**SUBJECT:** NuScale Power, LLC Supplemental Response to NRC Request for Additional Information No. 151 (eRAI No. 8974) on the NuScale Design Certification Application

## **Response to Request for Additional Information Docket No. 52-048**

**eRAI No.:** 8974

**NRC Question No.:** 03.08.04-23

Figure 3.7.2-96: **Nodes Used for ISRS for NPM Bay Walls at the Pool Floor (EL. 25' 0")** **Not Used**

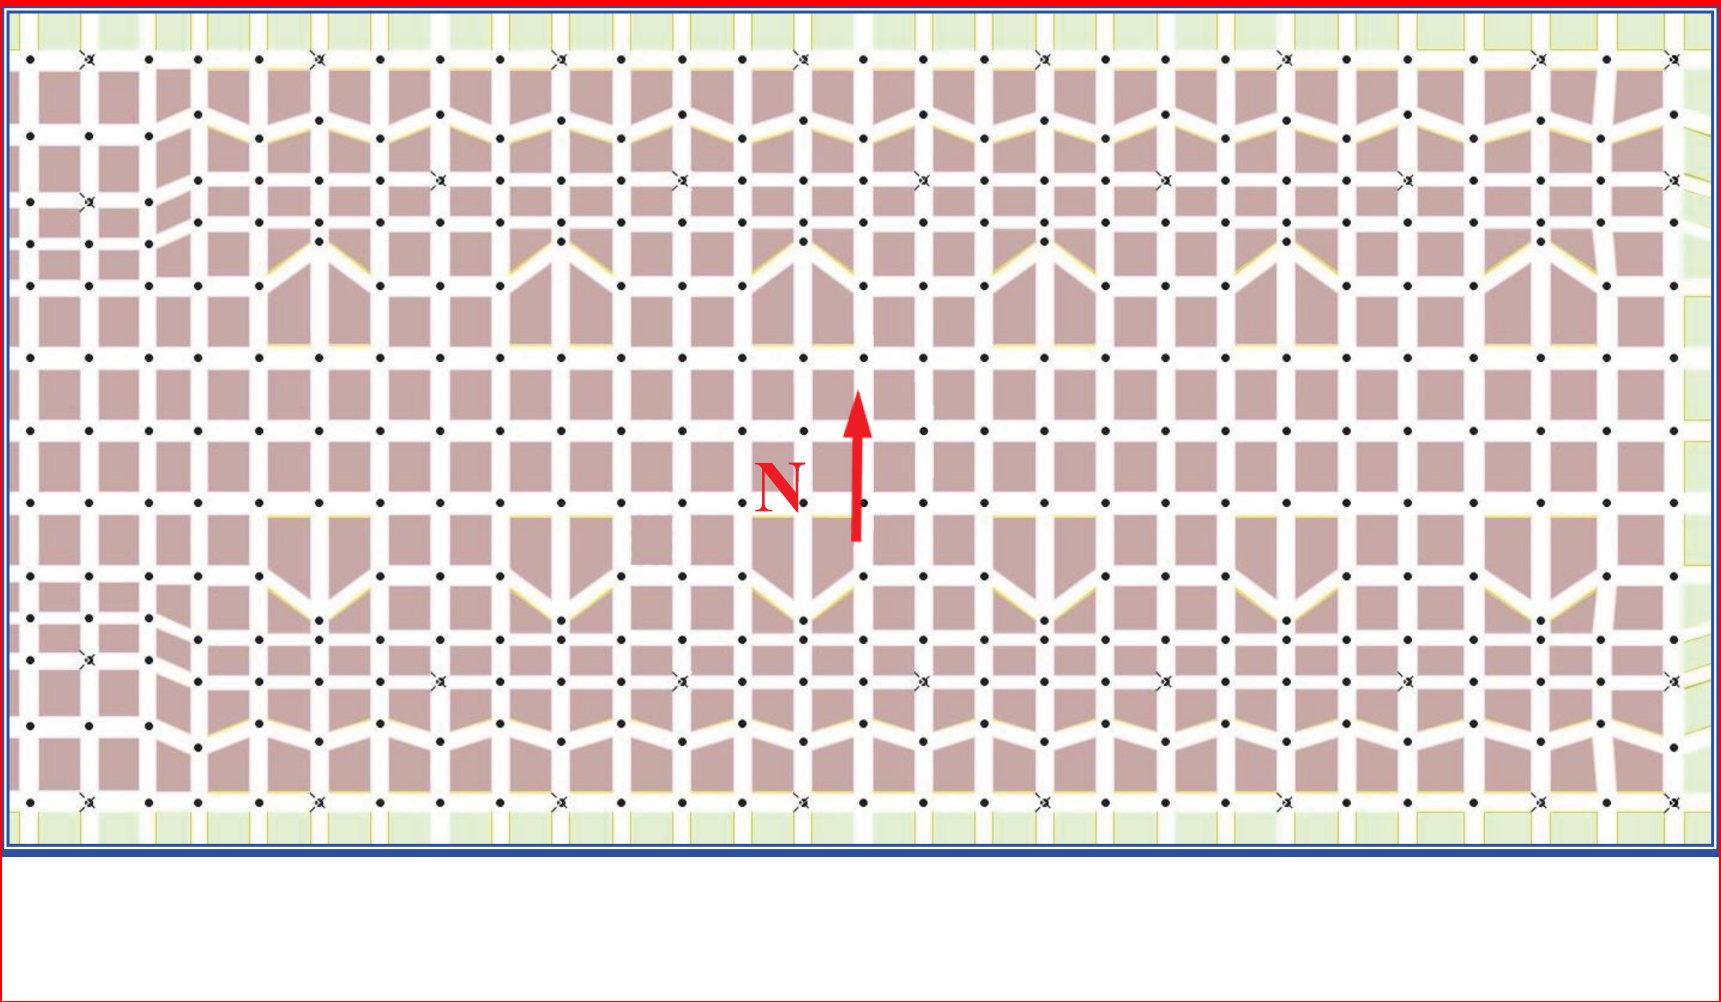
~~Figure 3.7.2-96 provides node locations that were used to develop the ISRS for the NPM bay walls at the pool floor. The enveloping ISRS for these locations are provided in Figure 3.7.2-115.~~

FSAR Tier 2, Sections 3.7.2.5.5, 3.7.2.5.6, 3.7.2.5.7, 3.7.2.9.1.5, and 3.8.4.8 and FSAR Tier 2, Tables 1.8-2, 3.7.2-54 through 3.7.2-58, and 3B-28 and FSAR Tier 2, Figures 3.7.2-96, 3.7.2-97, 3.7.2-115, 3.7.2-116, and 3.7.2-156 through 3.7.2-171 have been revised as described in the response above and as shown in the markup provided in this response.

Figure 3.7.2-97: **NPM Lug Restraint Node Locations (EL. 71' 7")** **Not Used**

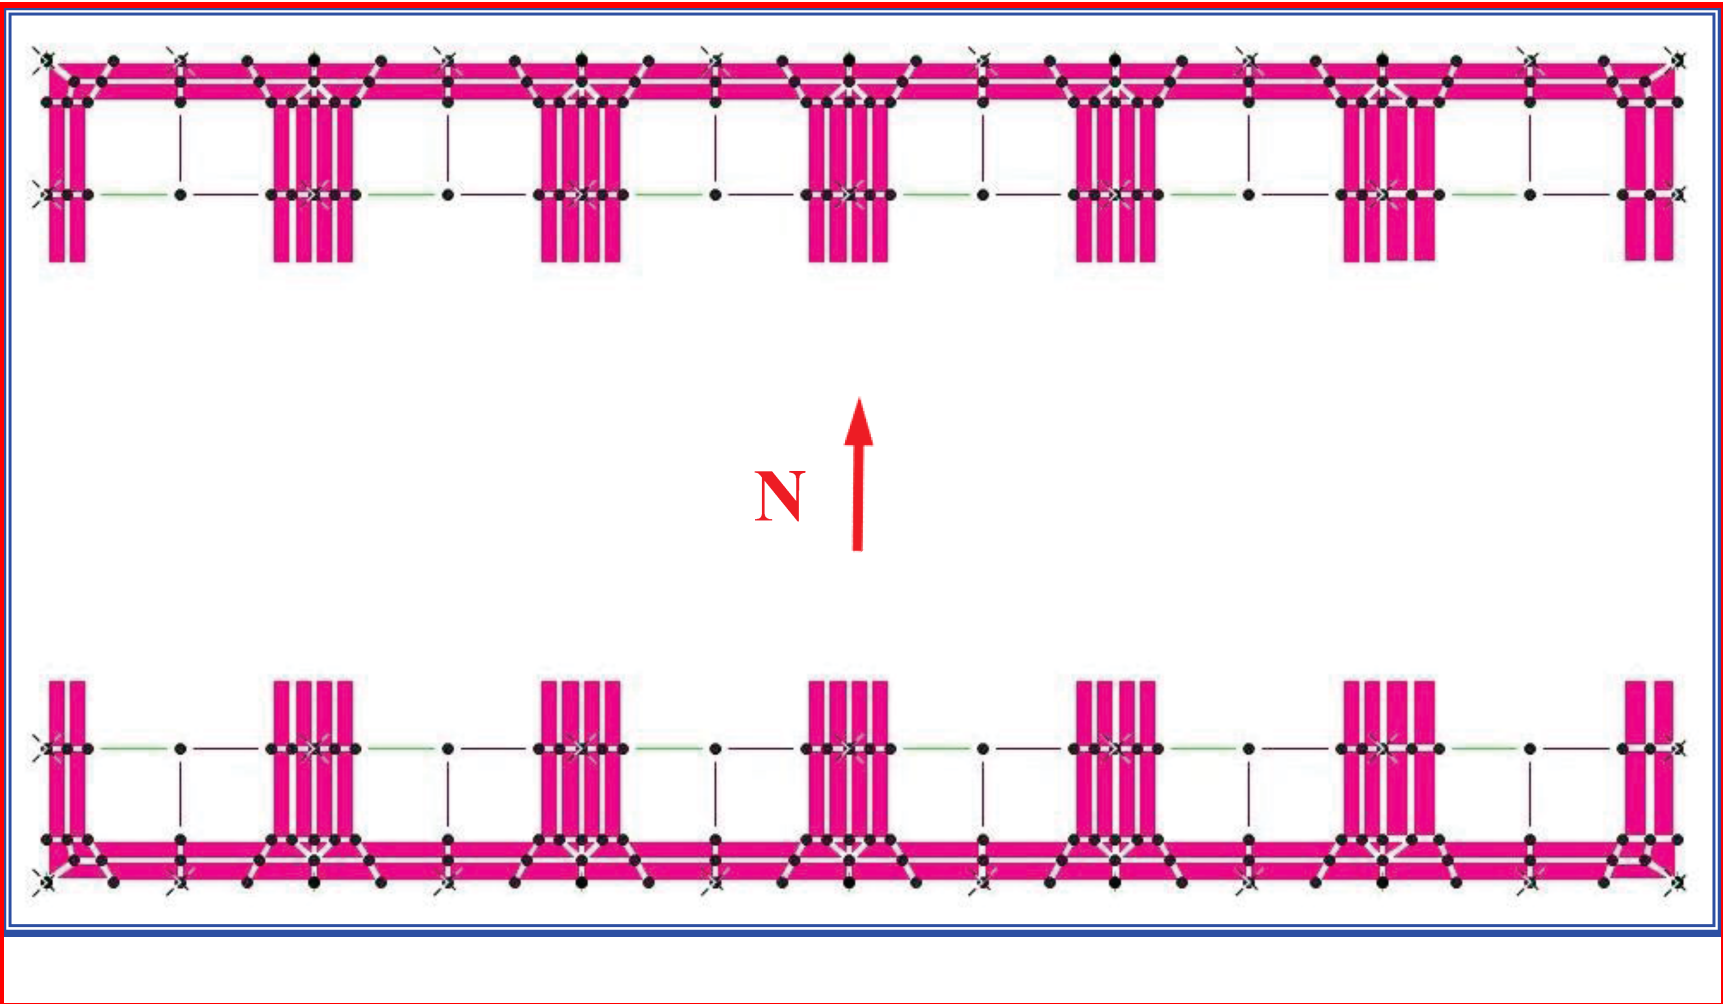
~~Figure 3.7.2-97 provides node locations that were used to develop the ISRS for the NPM bay walls at the lug restraints. The enveloping ISRS for these locations are provided in Figure 3.7.2-116.~~

Figure 3.7.2-116: ~~ISRS at NPM Lug Restraints~~Not Used

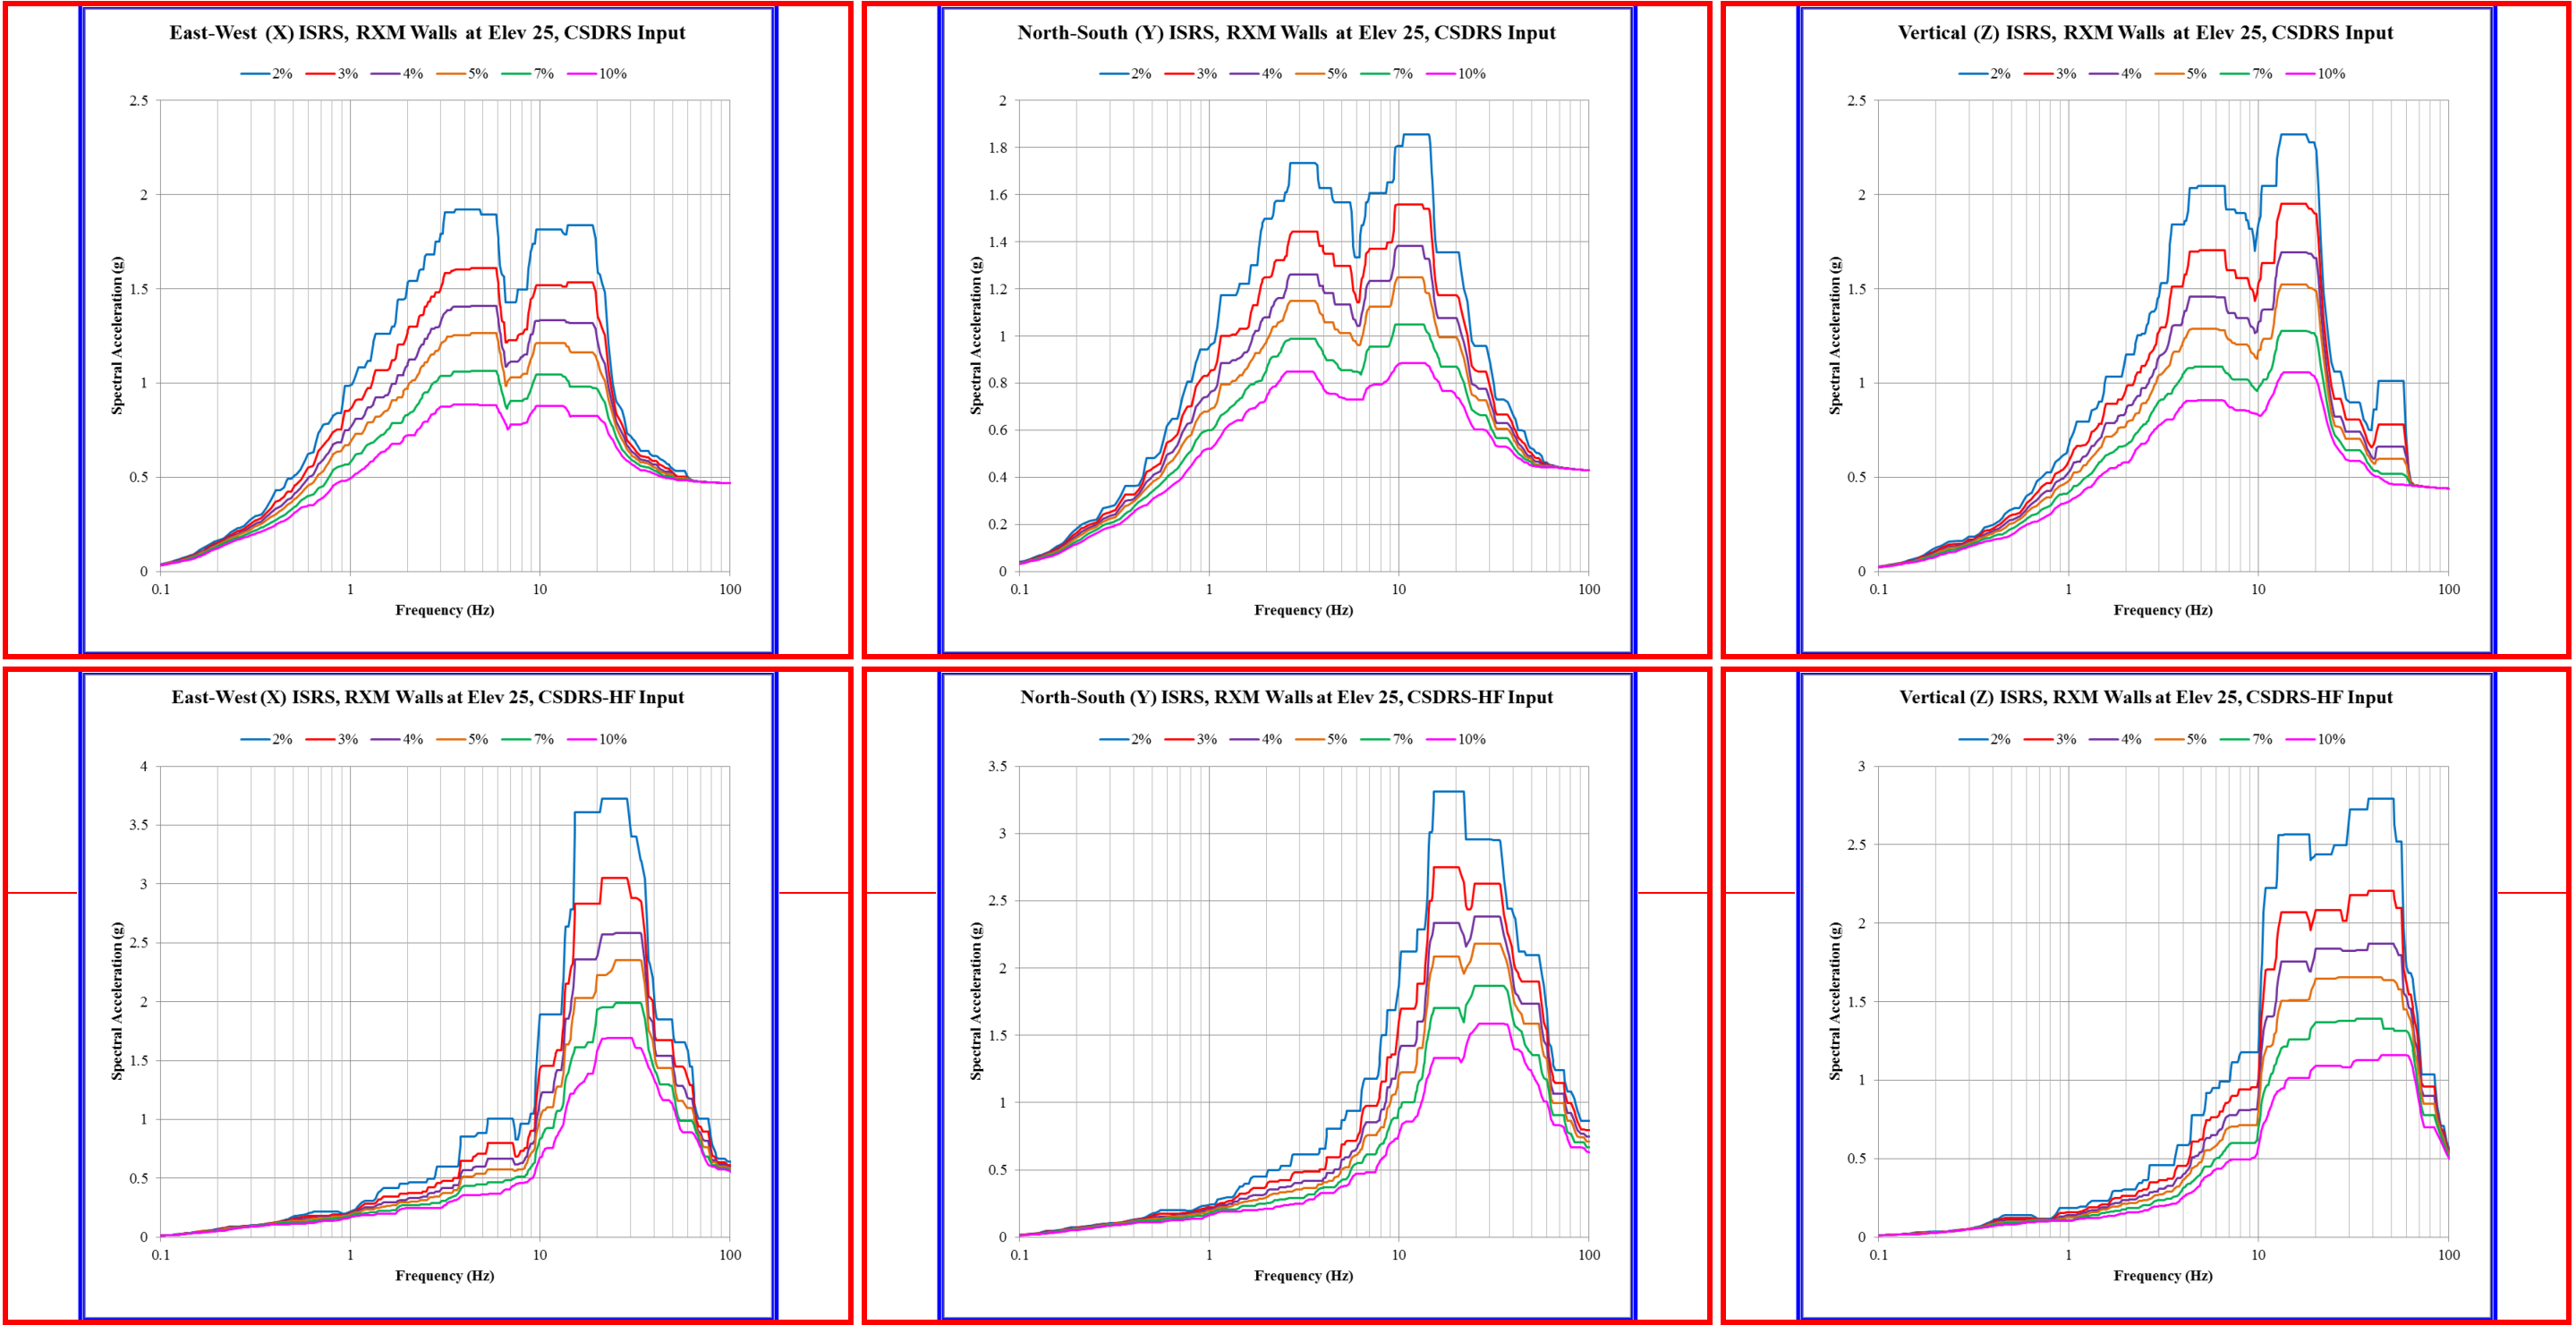
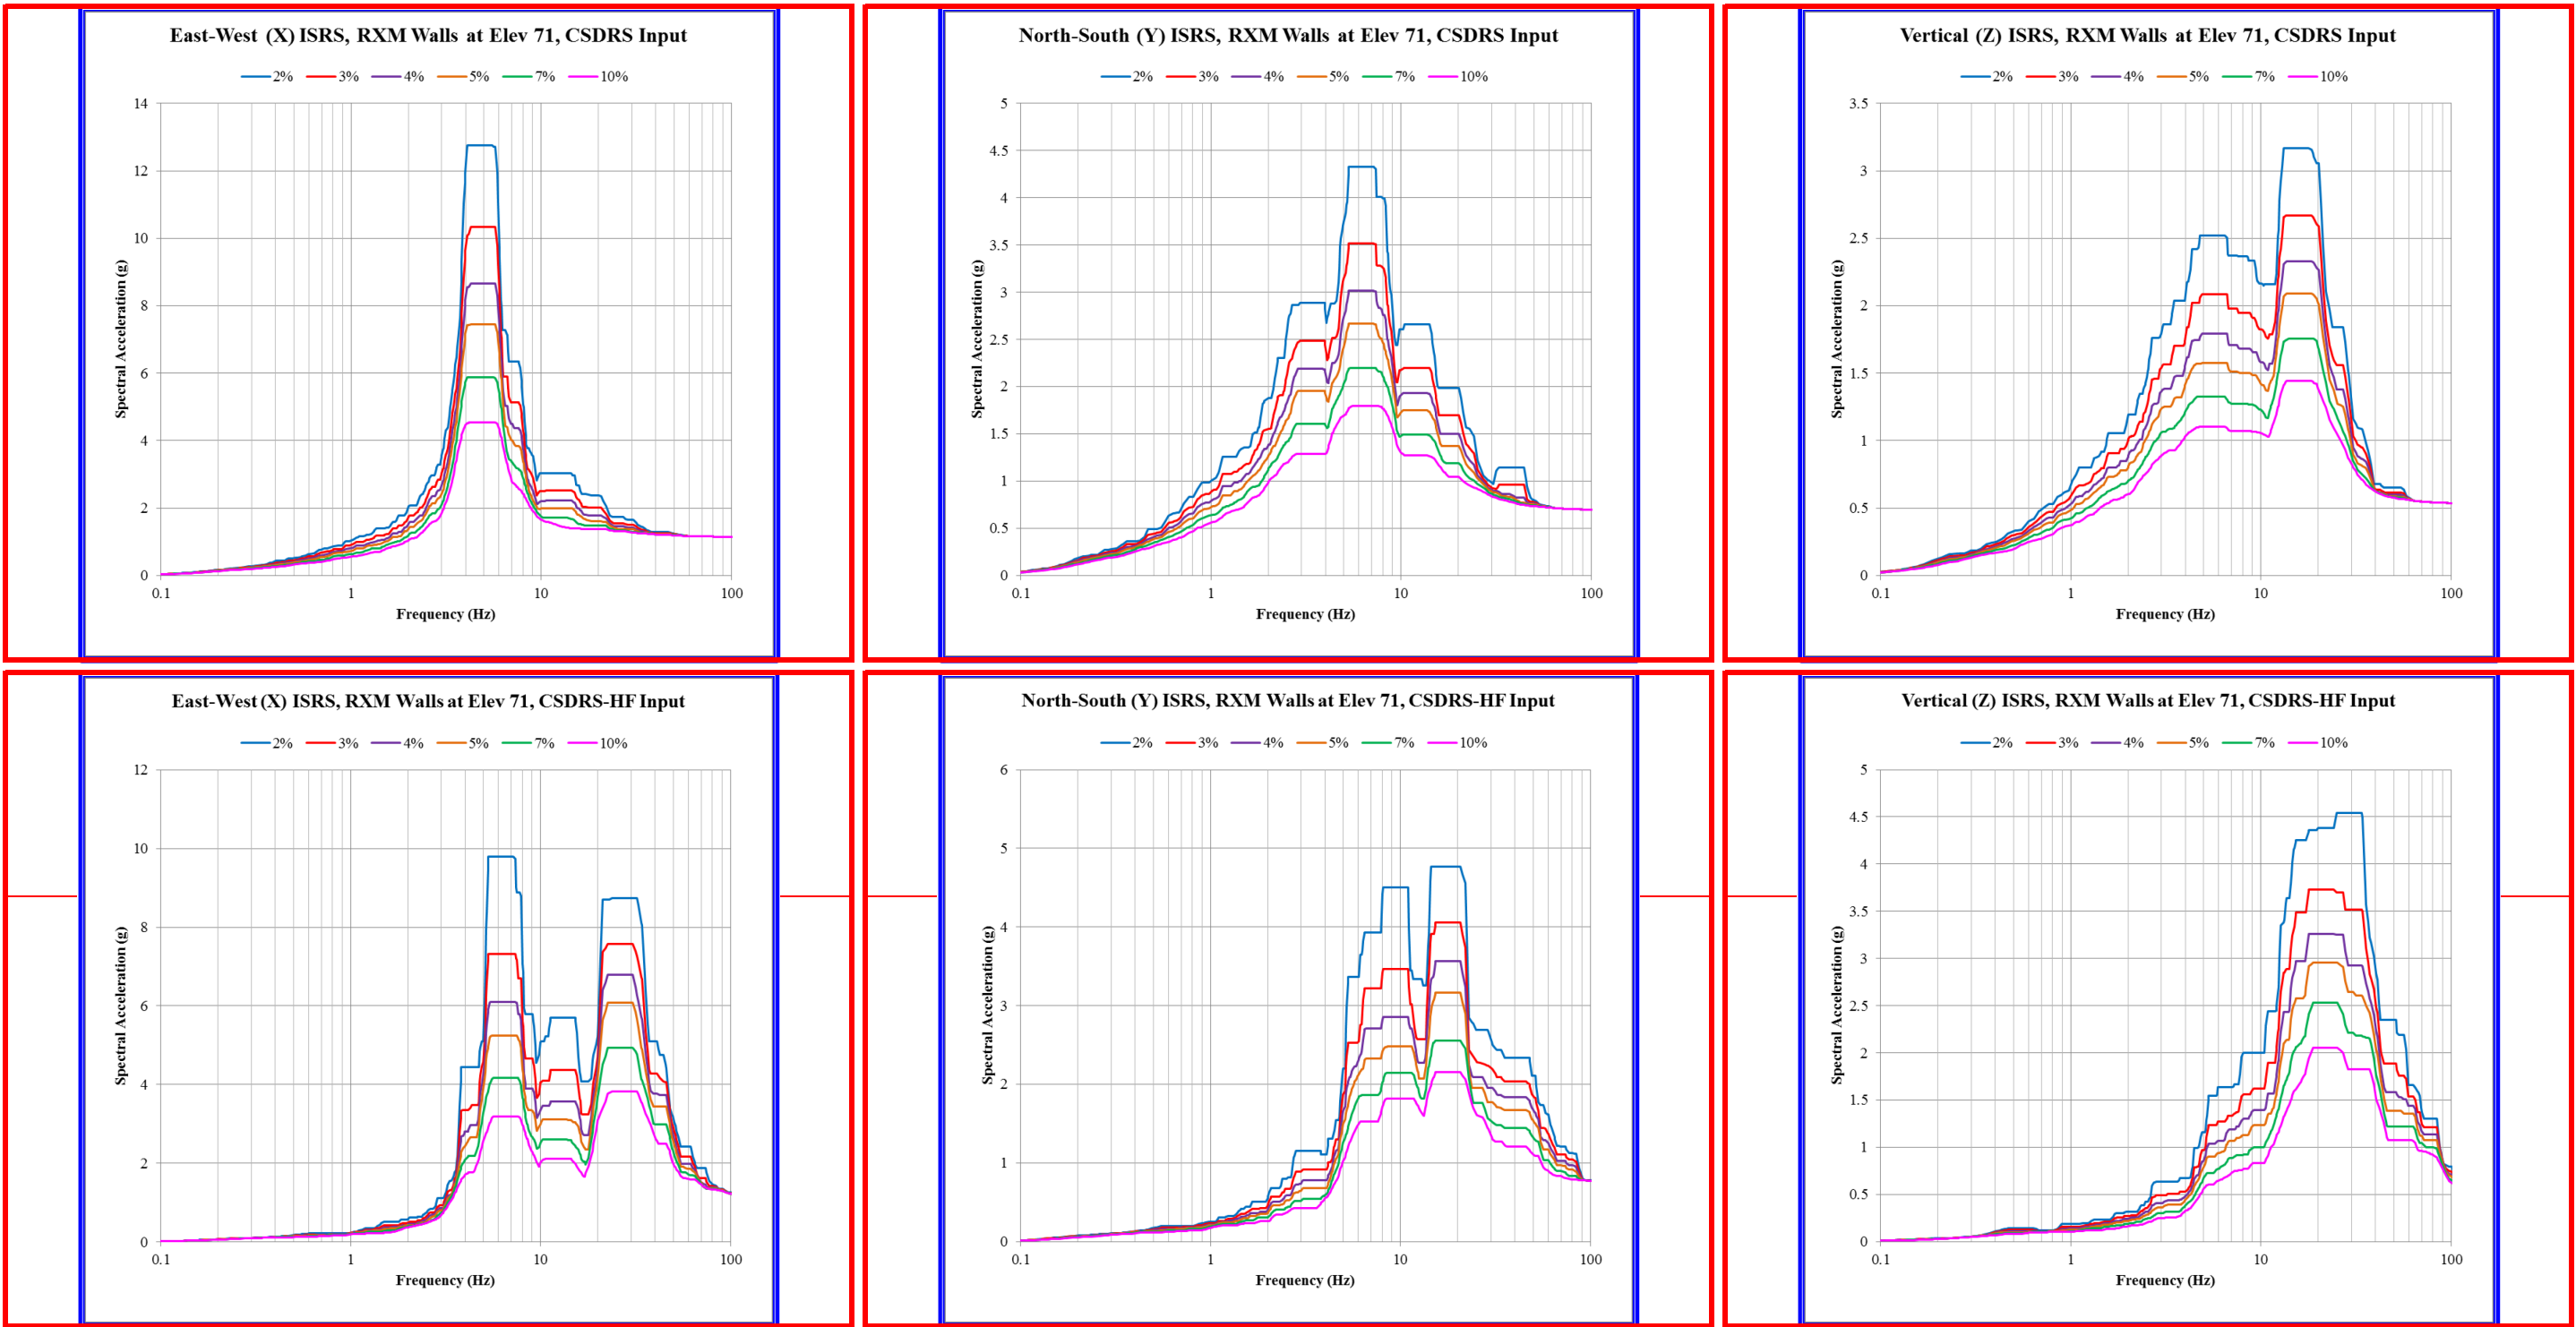
2. **Question:** Clarify if the node numbers in Table 3.7.2-55 are also applicable to the ISRS in Figure 3.7.2-116. If not, please provide FSAR markups to identify the nodes and respective location (e.g. tables and or figures) for the ISRS in 3.7.2-116. Further, please provide the coordinates and or figures showing the location for the nodes listed in Tables 3.7.2-54 and 3.7.2-55.

**Response:** Node numbers in Table 3.7.2-55 are not applicable to ISRS in Fig. 3.7.2-116. Figures 3.7.2-115 and 3.7.2-116 are removed from the FSAR as they do not constitute the standard design basis. Design-basis ISRS at the skirt and lug locations of NPM1 and NPM6 are shown in FSAR Figures 3.7.2-156 through 3.7.2-163.
